A. ADMINISTRATIVE REPORT & DECISION

DECISION:	<input type="checkbox"/> APPROVED	<input checked="" type="checkbox"/> APPROVED SUBJECT TO CONDITIONS	<input type="checkbox"/> DENIED
REPORT DATE:	November 8, 2016		
Project Name:	Dylan Short Plat		
Owner/Applicant:	Kenneth E. Neault, P.O. Box 2230, Issaquah, WA 98027		
Contact:	Jae Kim, Encompass Engineering & Surveying, Inc., 165 NE Juniper St., Ste. 201 Issaquah, WA 98027		
File Number:	LUA16-000754, SHPL-A		
Project Manager:	Clark H. Close, Senior Planner		
Project Summary:	<p>The applicant is requesting approval of a 2-lot short plat. The site is 22,912 square feet (0.53 acres) and is located at 1909 Jones Ave NE (APN 3344500120) and would be for the future development of one new single family home. The property is in the Residential-4 (R-4) zoning district. The proposed residential lots are approximately 9,993 SF and 10,732 SF in area with an average lot size of 10,363 SF. The residential density is 4.2 dwelling units per net acre. Access is proposed from a shared driveway tract from Jones Ave NE along the north property line. A second driveway approach is proposed to be retained to the existing single family home. The native soil

DYLAN SHORT PLAT
KEN NEAULT
PRELIMINARY
GRADING / UTILITY / DRAINAGE PLAN

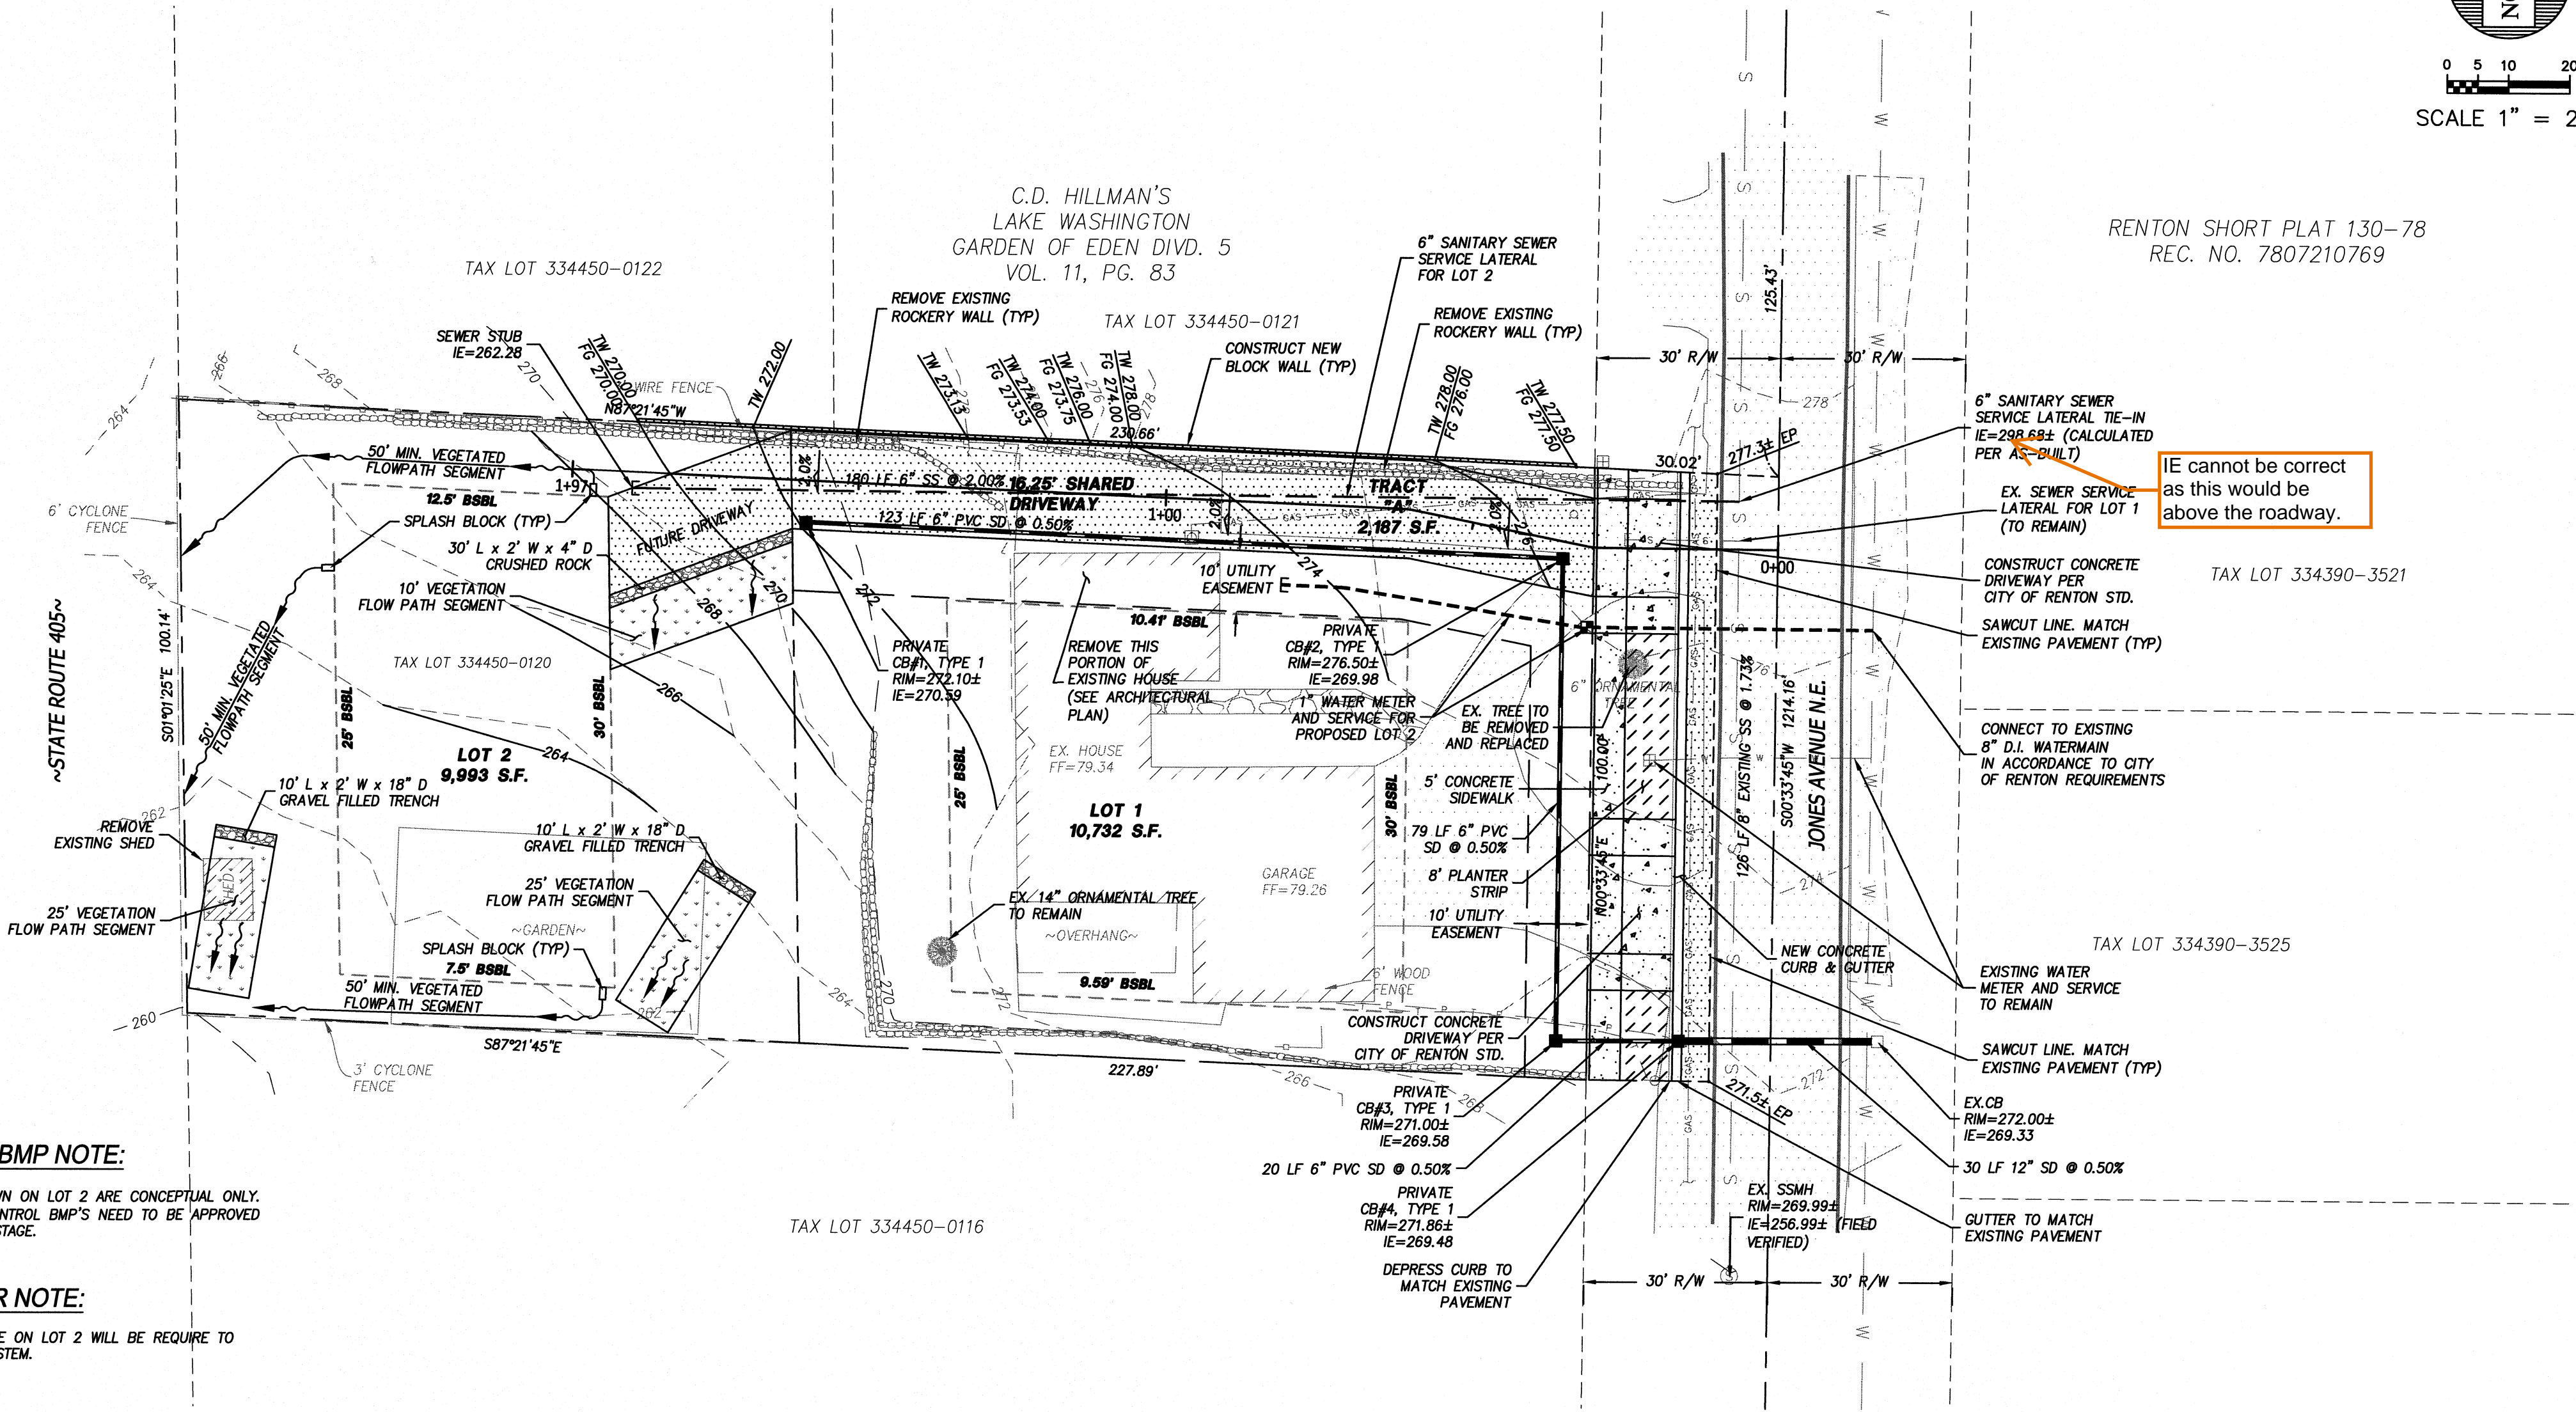
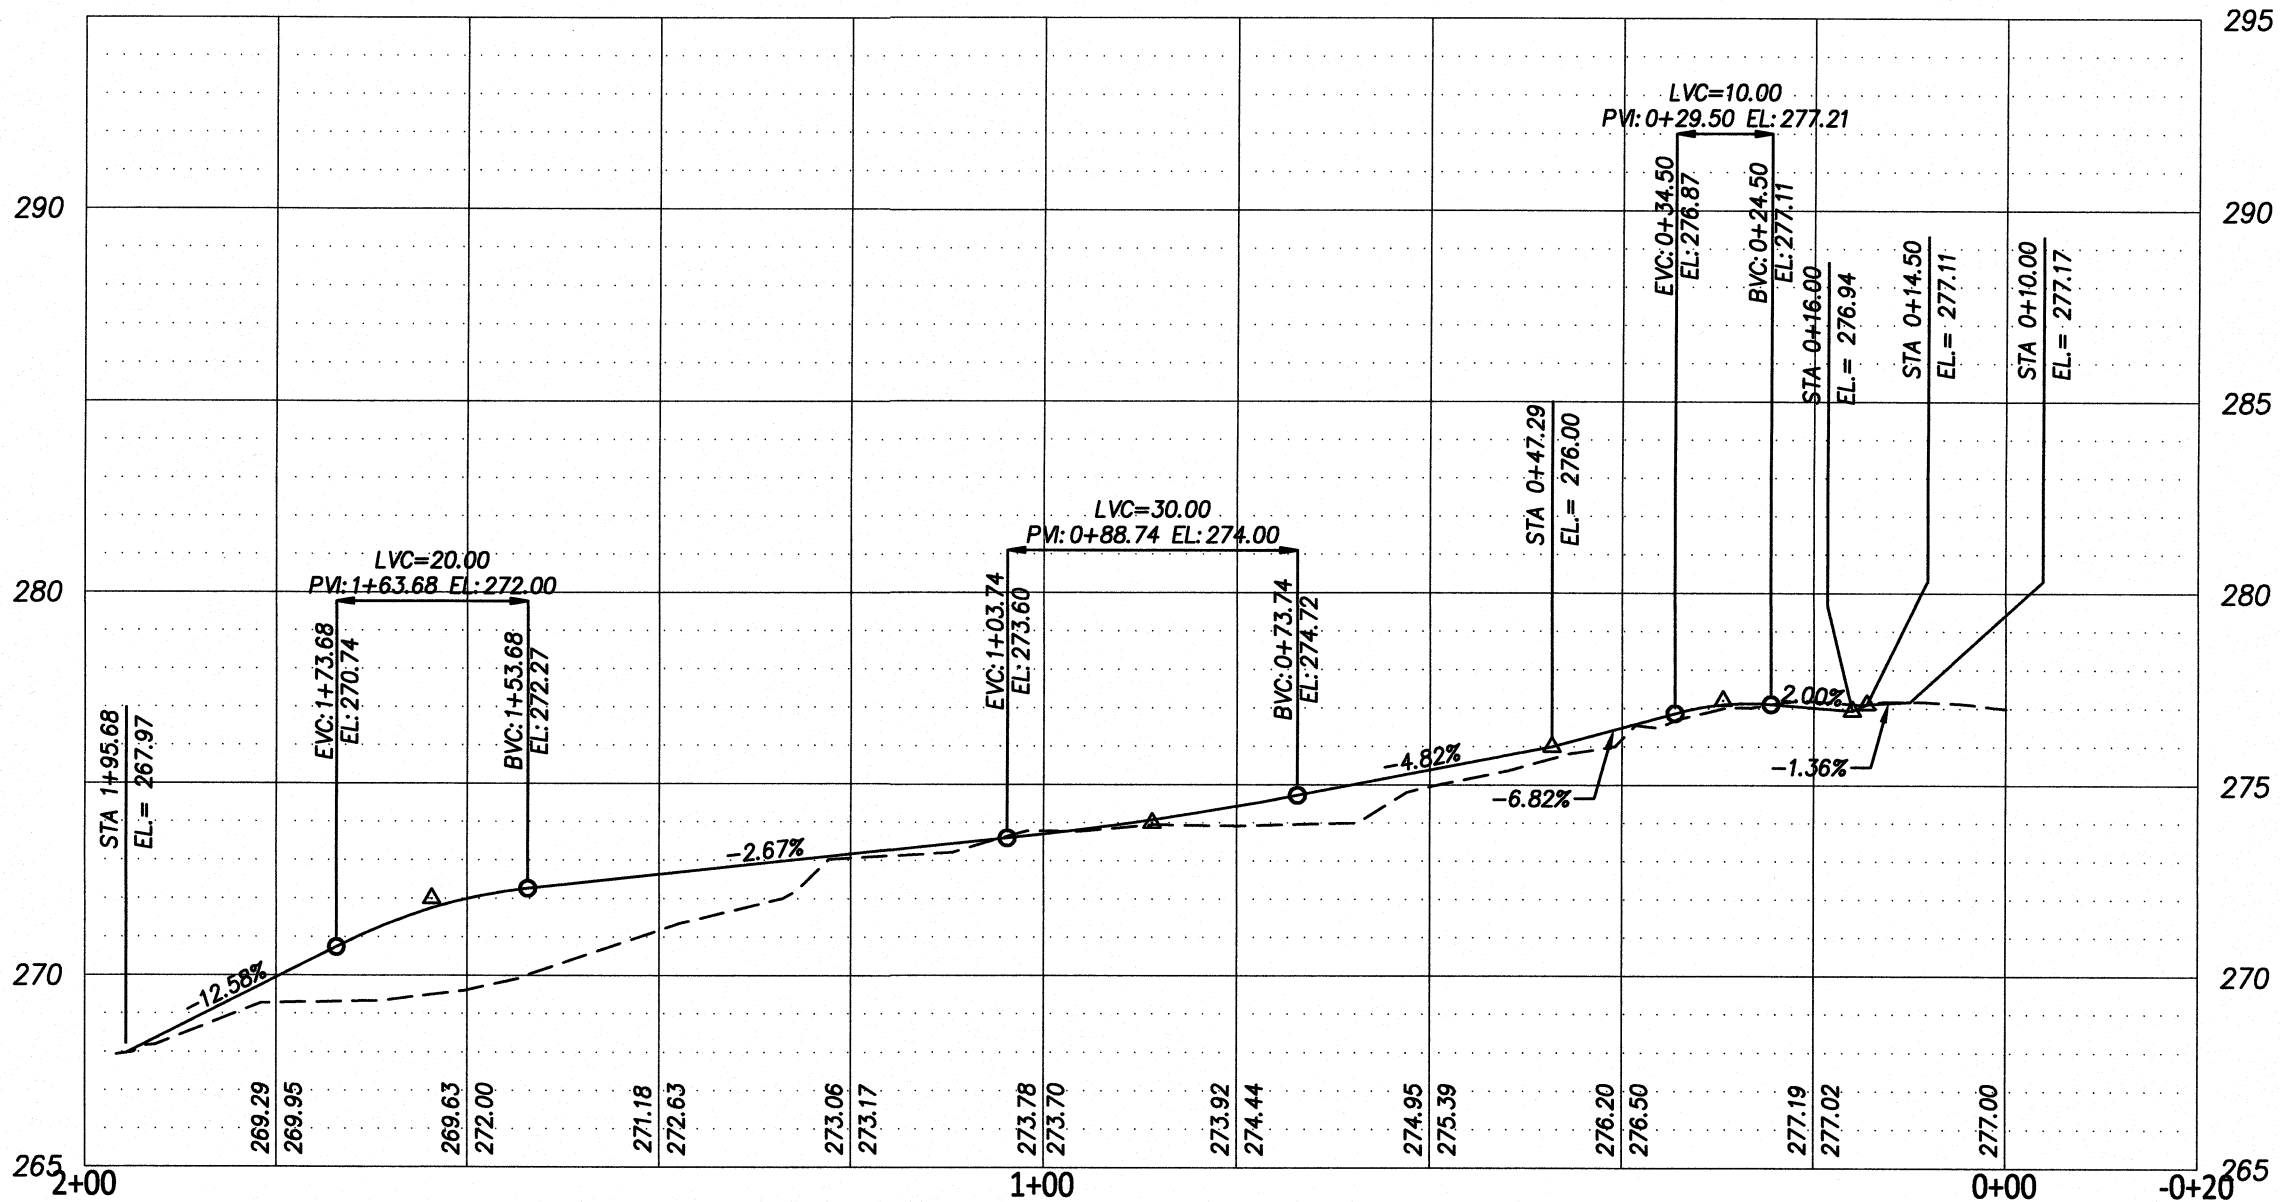
4. The development is required to provide flow control Best Management Practices (BMPs) to help mitigate the new runoff created by this development. The submitted drainage plans identifies the use of basic dispersion as the proposed flow control BMPs for Lot 2. The final drainage plan and drainage report submitted with the utility construction permit shall account for the recommendations outlined in the geotechnical report submitted with regards to stormwater discharge on the site.

- a. The proposed preliminary drainage plans conflict with the recommendations noted in the geotechnical report with regards to point discharges over the slope to the west of the property and keeping surface water on site. As a condition of approval, applicant will be required to comply with the recommendations of the geotechnical report.

- a. The retaining wall shown on the site plan at the north property line appears to be on the neighboring property.
- b. The applicant will need to provide drainage plans for the wall drain with the construction permit application.
